MIL-M-28787/536
AMENDMENT 1
29 September 1993

MILITARY SPECIFICATION

MODULES, STANDARD ELECTRONIC

MEMORY INTERFACE II MODULE, KEY CODE EWD

FIGURE 1. EWD functional block diagram.

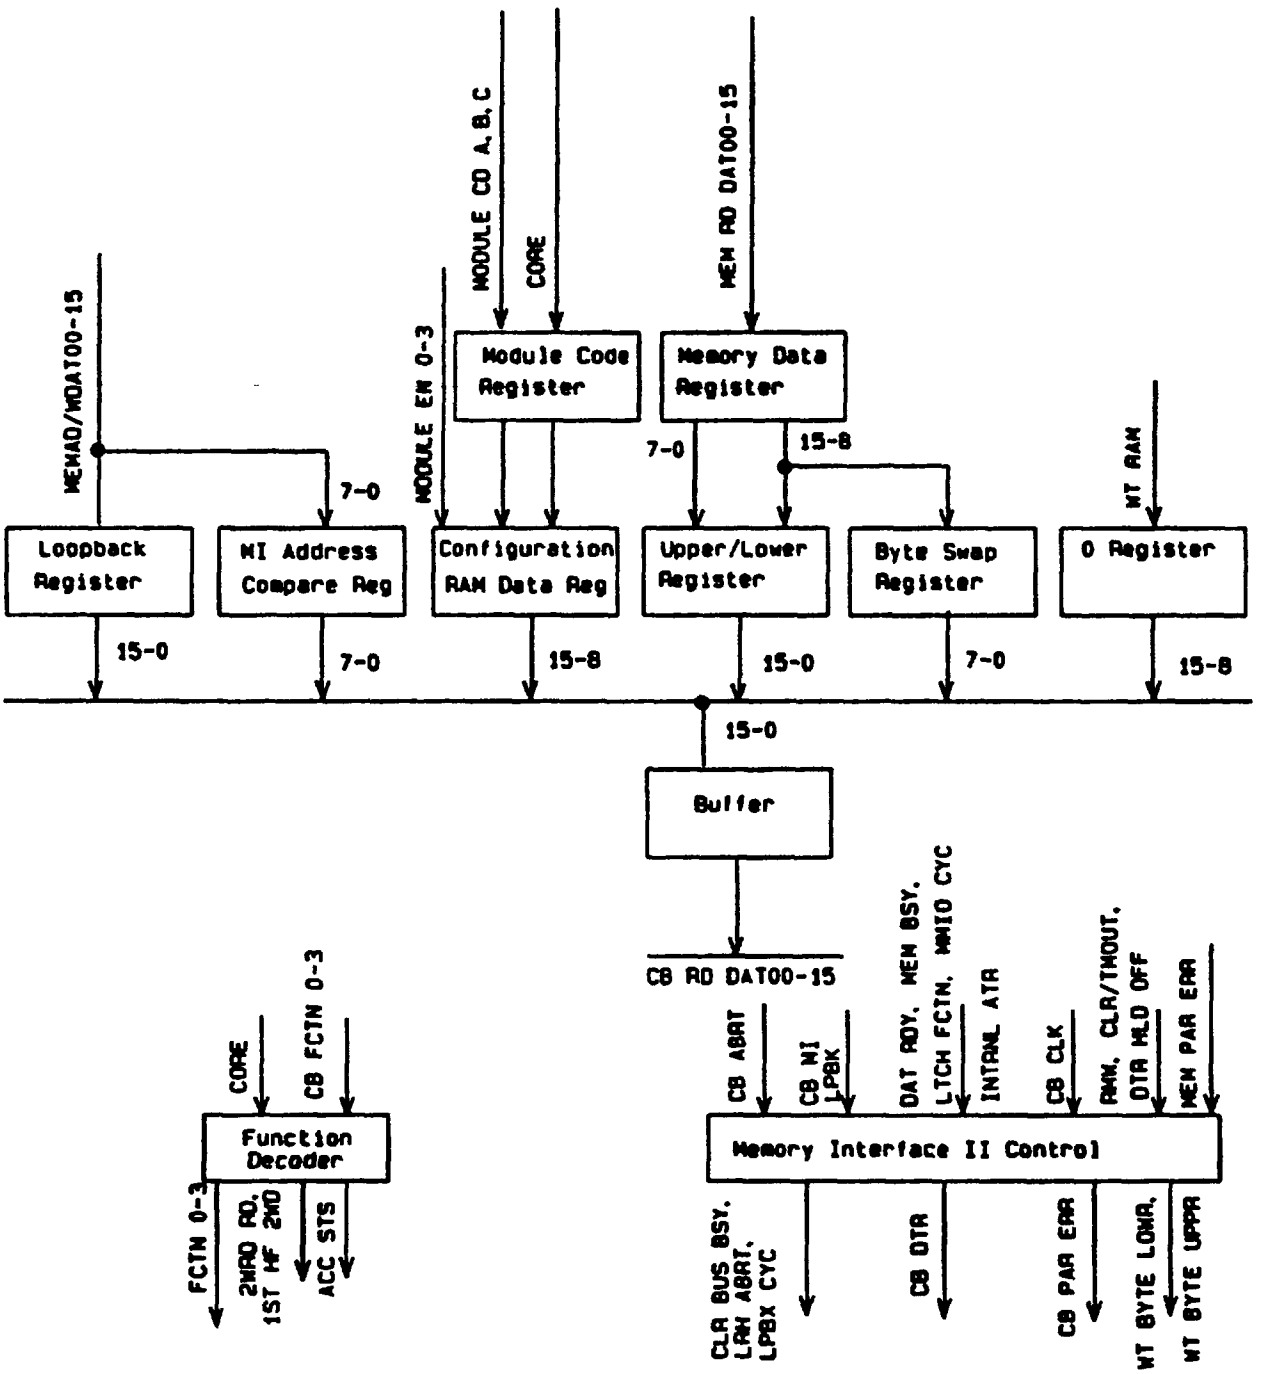
FIGURE 1: Delete and substitute new figure 1 as printed on page 5 of this amendment.

FIGURE 11. Input timing parameters for table XV.

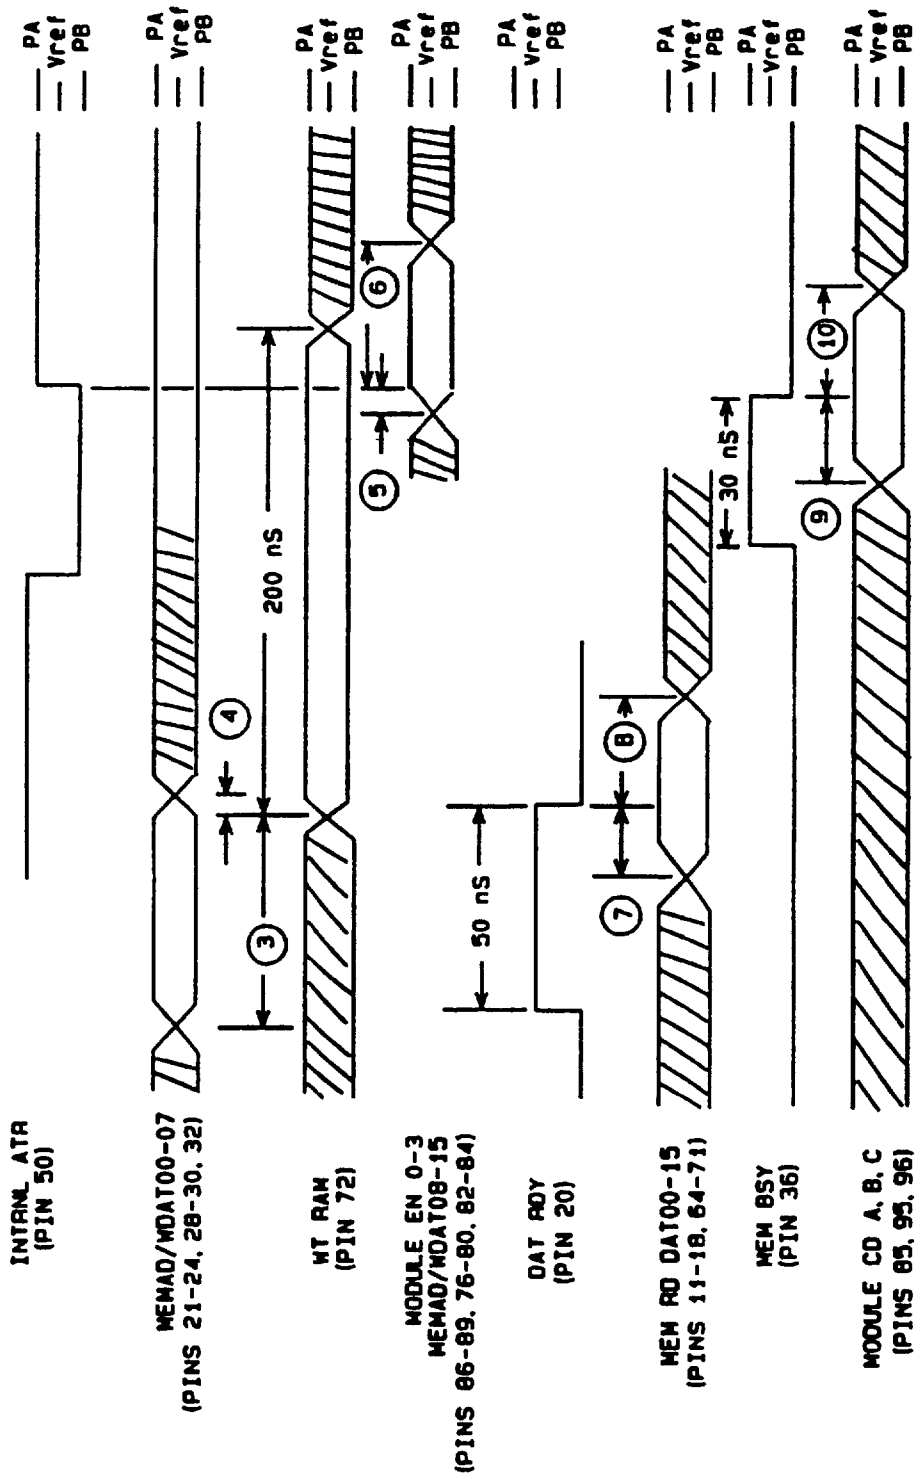
FIGURE 11: Delete and substitute new figure 11 as printed on page 6 of this amendment.

FIGURE 12c. Dynamic waveforms for table XVII.

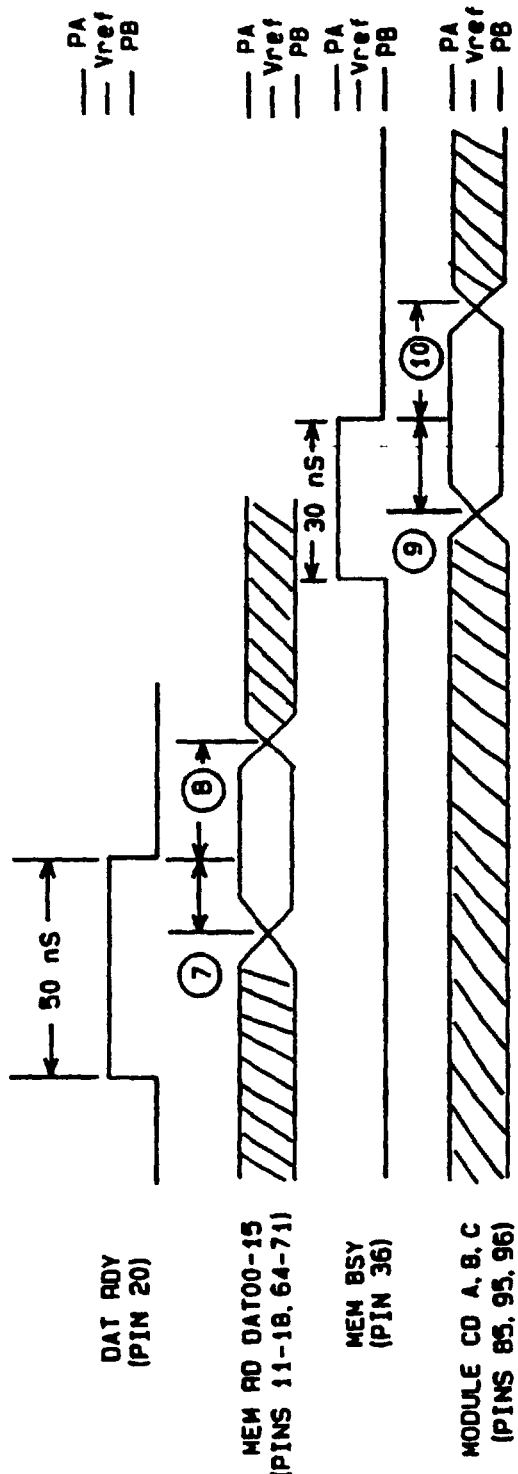
FIGURE 12c: Delete and substitute new figure 12c as printed on page 7 of this amendment.
